IMPORTANT RECALL INFORMATION #80912

**SUBJECT: RECALL CAMPAIGN #80912
2008/2009 Class C - Front Clearance Lights Wiring**

RECALL BULLETIN:
80912

SUBJECT:
Installing
protection for
front clearance
light wire harness

Figure 1

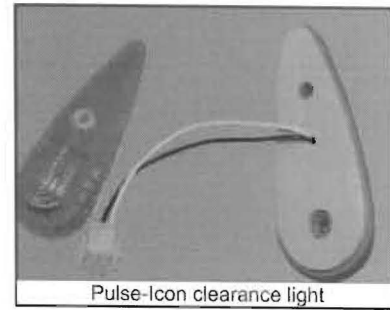
8. A. **Pulse or Icon products:** The light base is connected to the wiring. Allow the base to hang from attached wires while repairs are performed. See Figure 1.

Figure 2

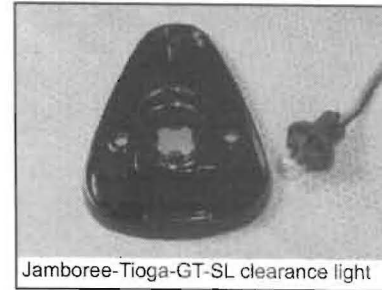
B. **Jamboree, Tioga, Jamboree GT or Tioga SL products:** The light base (shown in Figure 2) will need to be removed to access the clearance light wires. Remove this piece, using care to avoid disconnecting the bulb socket assembly attached to the clearance light wire harness. Retain the light base and original gaskets for reassembly.

Figure 3

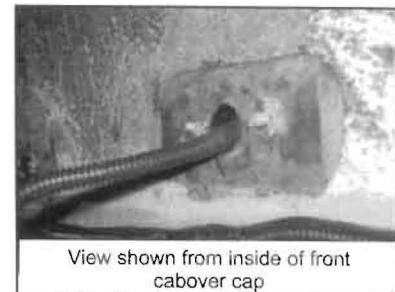
9. Inspect all clearance light wires and clearance light wire harness for evidence of being chafed or cut by the edges of the steel plate (bonded to the inside of the cap), through which they pass:

10. Cover all exposed clearance light wires with 3/8" diameter auto loom in the area where they pass through the front cap. See Figure 3. Apply sealant to the inside of the auto loom to keep wires in place after light reinstallation. Allow sealant to fully cure before reinstalling the lights.

Figure 4

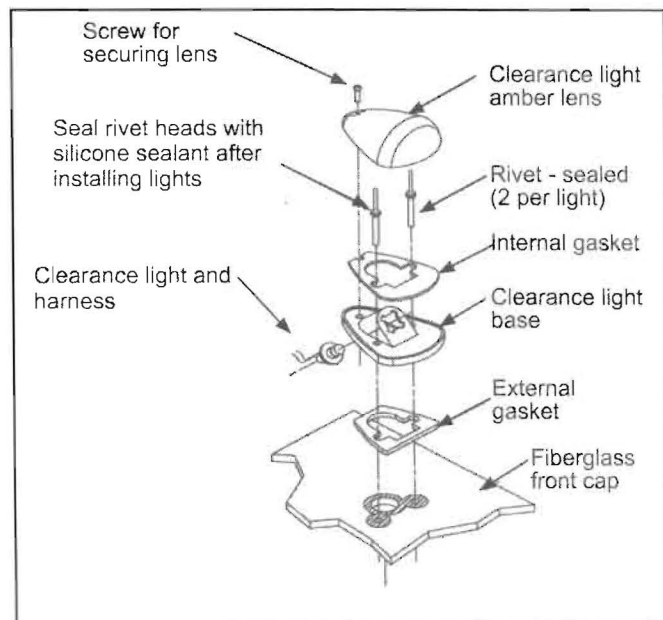
Refer to Figure 4 for clearance light part installation. Clearance light parts may be different in appearance than those shown.

1. Disconnect the clearance light from the front clearance light harness, using care to keep the wires from dropping into the interior cavity of the cap. Discard the damaged clearance light.
2. Connect the wires for the new clearance light to the front clearance light harness. Use insulated butt connectors and electrical tape as required.

3. Cover all exposed clearance light wires with 3/8" diameter auto loom in the area where they pass through the front cabover cap. Apply sealant to the inside of the auto loom to keep wires in place after light reinstallation. Allow sealant to fully cure according to manufacturer's instructions.
4. Apply the external gasket included with the new light.
5. Insert the bulb socket, attached to the light wires, into the opening in the clearance light base before reattaching the light base.

Figure 5

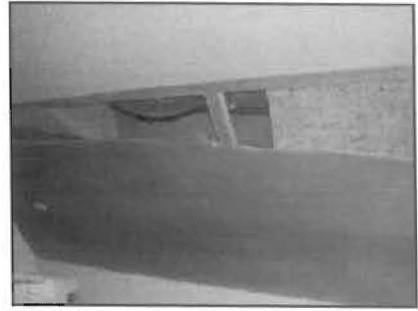
5. Pull back the insulation inside the cap to expose damaged wires. Remove and discard any damaged insulation. See Figure 5.
6. Cut and discard the damaged section of wire harness. Use care to keep remaining wires from dropping down inside the cap.
7. Install replacement wires of the same wire gauge and specifications, using insulated butt connectors.
8. Cover all exposed wires with 3/8" diameter auto loom.
